STATE OF CONNECTICUT
CONNECTICUT SITING COUNCIL

IN RE: :
: :
WATERTOWN SOLAR ONE, LLC AND VCP, : PETITION NO. 1417
LLC D/B/A VEROGY PETITION FOR A :
DECLARATORY RULING, PURSUANT TO :
CONNECTICUT GENERAL STATUTES §4-176 :
AND §16-50K, FOR THE PROPOSED :
CONSTRUCTION, MAINTENANCE AND :
OPERATION OF A 1.975-MEGAWATT-AC :
SOLAR PHOTOVOLTAIC ELECTRIC :
GENERATING FACILITY LOCATED AT 669 :
PLATT ROAD, WATERTOWN, : AUGUST 28, 2020
CONNECTICUT, AND ASSOCIATED :
ELECTRICAL CONNECTION :

RESPONSES OF WATERTOWN SOLAR ONE, LLC
AND VCP, LLC D/B/A VEROGY TO
CONNECTICUT SITING COUNCIL INTERROGATORIES - SET ONE

Figure: Greenhouse Gas Emissions over 20-years for Natural Gas Scenario vs. Solar Scenario per 67,955 MWh.

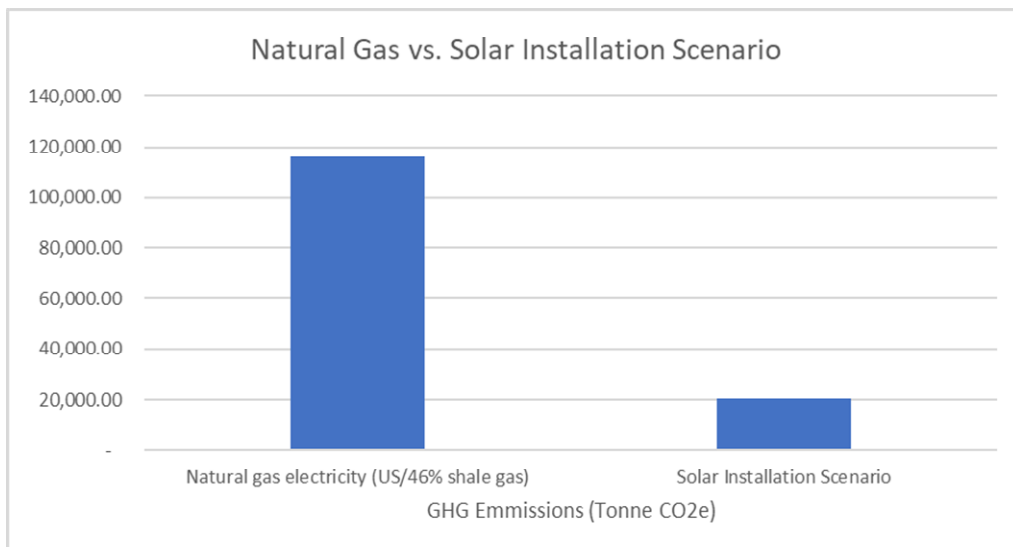
The Greenhouse Gas (GHG) Assessment in Appendix M of Council Petition No. 1352 compared the life cycle GHG emissions from a solar project to a scenario where the solar project is avoided and an equivalent amount of natural gas-fired electric generation operated for the estimated life of the solar facility. For the proposed project, how would the net GHG emissions (or reduction) over the life of the solar facility and carbon debt payback be affected under this natural gas-fired generation versus proposed solar generation scenario?

Using the methods and general assumptions provided in Appendix M of Council Petition No. 1352 as a foundation and applying those principles proportionally to the subject project (Petition No. 1417) we estimate that there would be an 83% reduction in GHG emissions by pursuing solar instead of natural gas.

Specifically, over 20 years we estimate the Watertown Solar One project will generate 67,955 MWh of electricity, while emitting approximately 20,286 tons of CO₂e. To achieve the equivalent MWh production over 20 years, a natural gas generator would emit an estimated 116,345 tons of CO₂e. See the figure below.

TSM-DEG15MC.20(II)

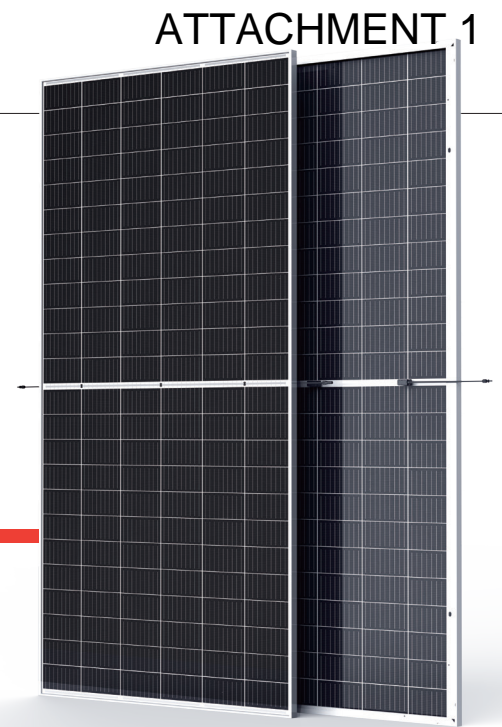
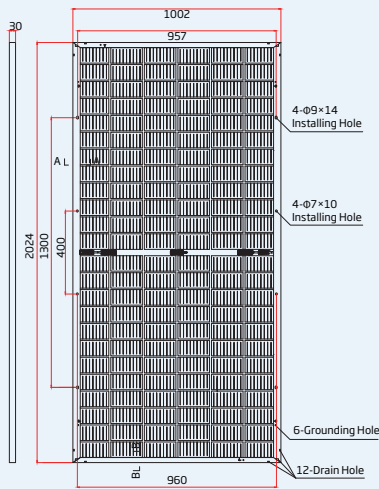
Referencing Sheet OP-1, provide the specifications sheets for the proposed 380 Watt and 390 Watt solar photovoltaic panels.

See Attachment 1.

**Response to Comment # 19
 Proposed Conditions Map**

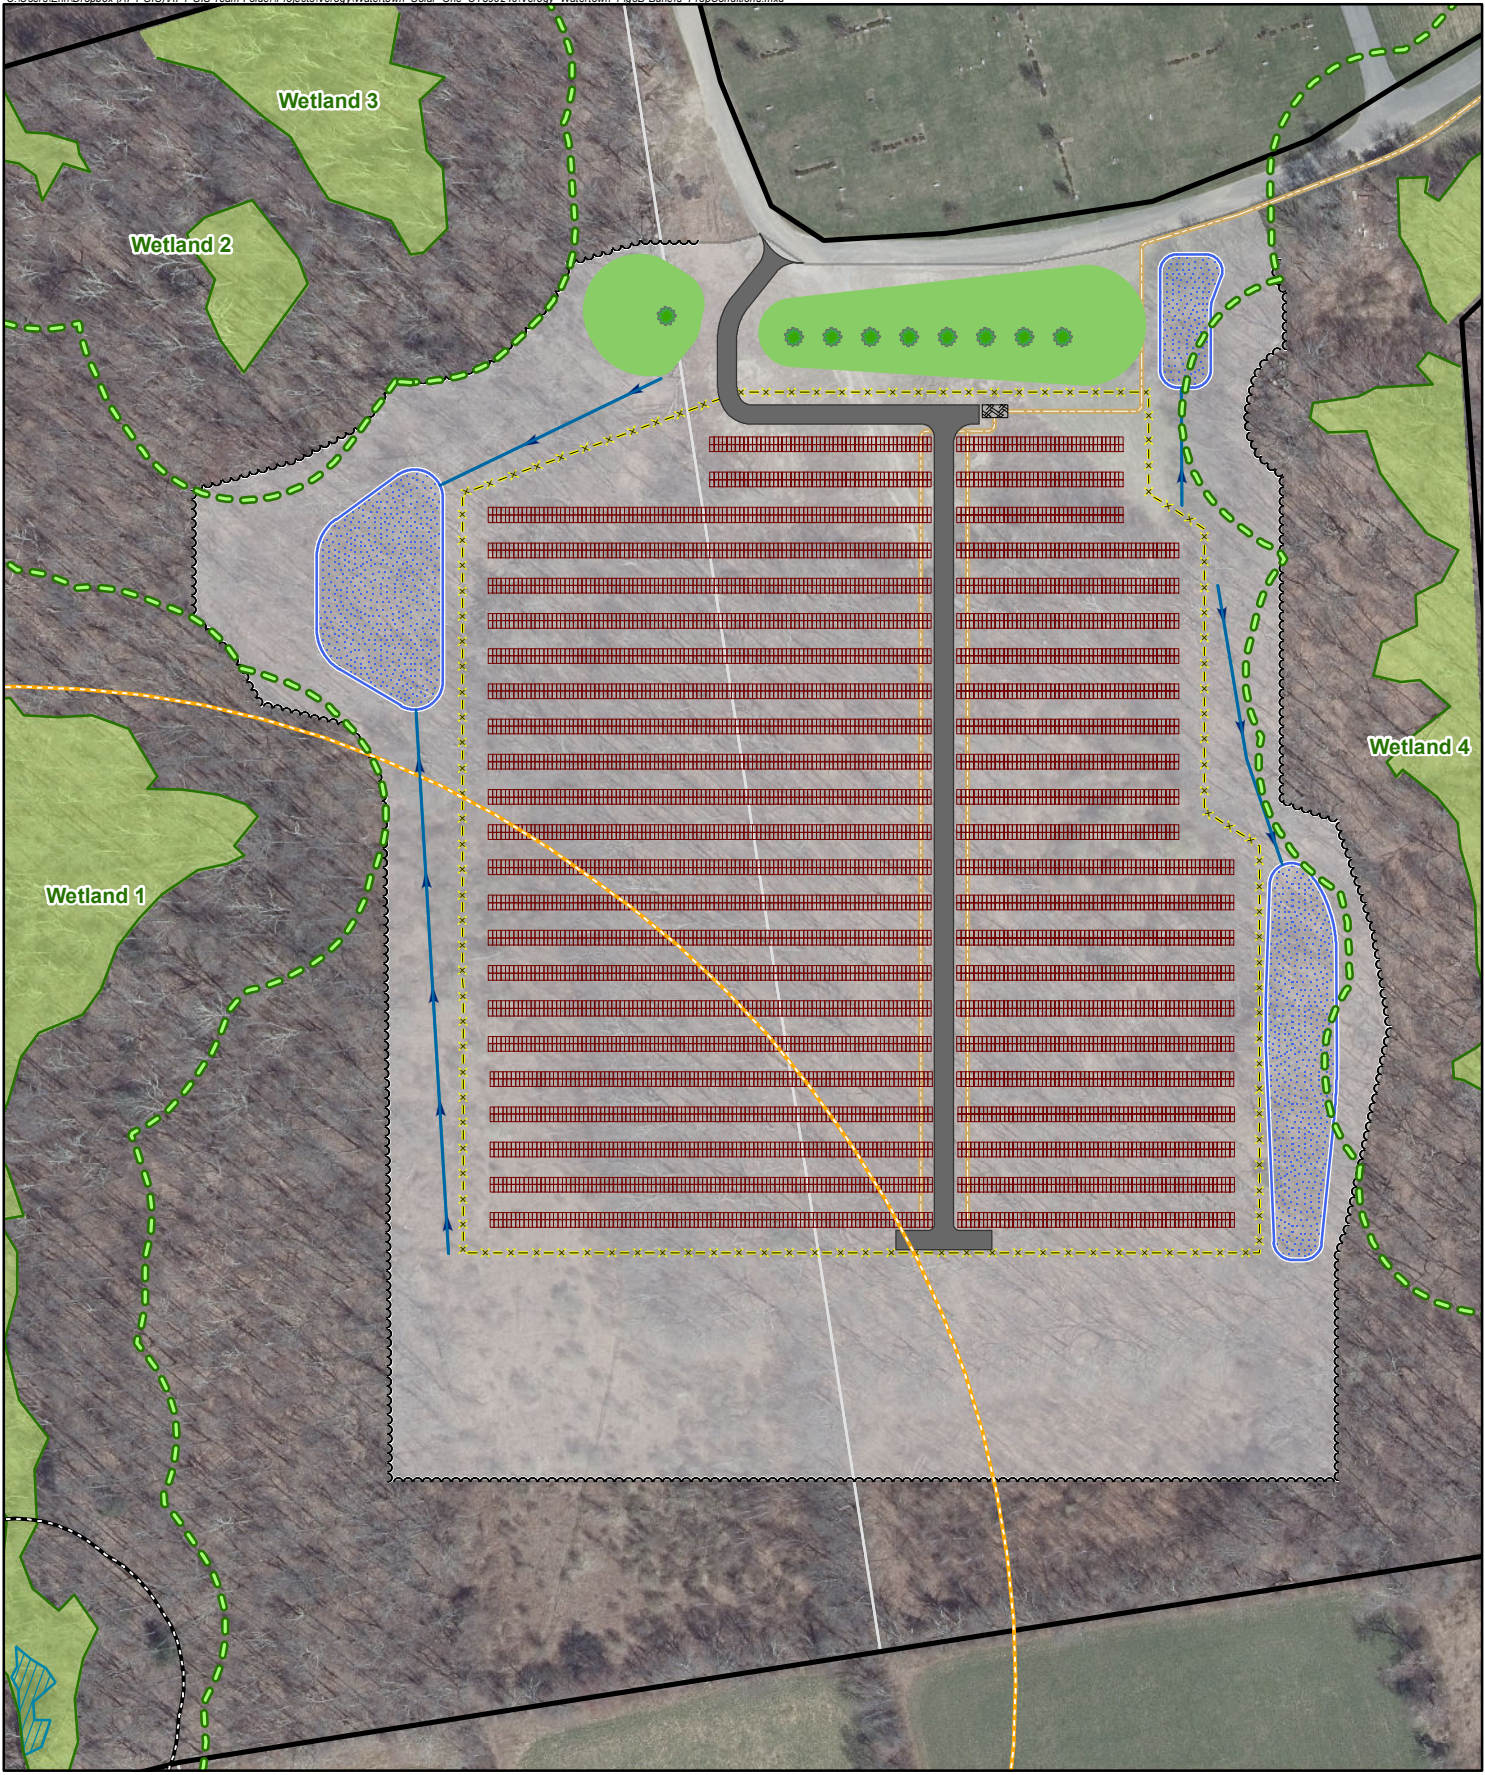
Referencing Figure 3 on page 9 of the Environmental Assessment (EA), Proposed Conditions Map, please provide a zoomed-in aerial map of the proposed project footprint that includes wetland buffers, and vernal pool envelope and critical terrestrial habitat distances.

Attachment 2 includes is a zoomed-in aerial map depicting the project area, a 100-foot upland review area, and vernal pool envelope and critical terrestrial habitat distances as shown on Figure 5, page 24 of the Petition.
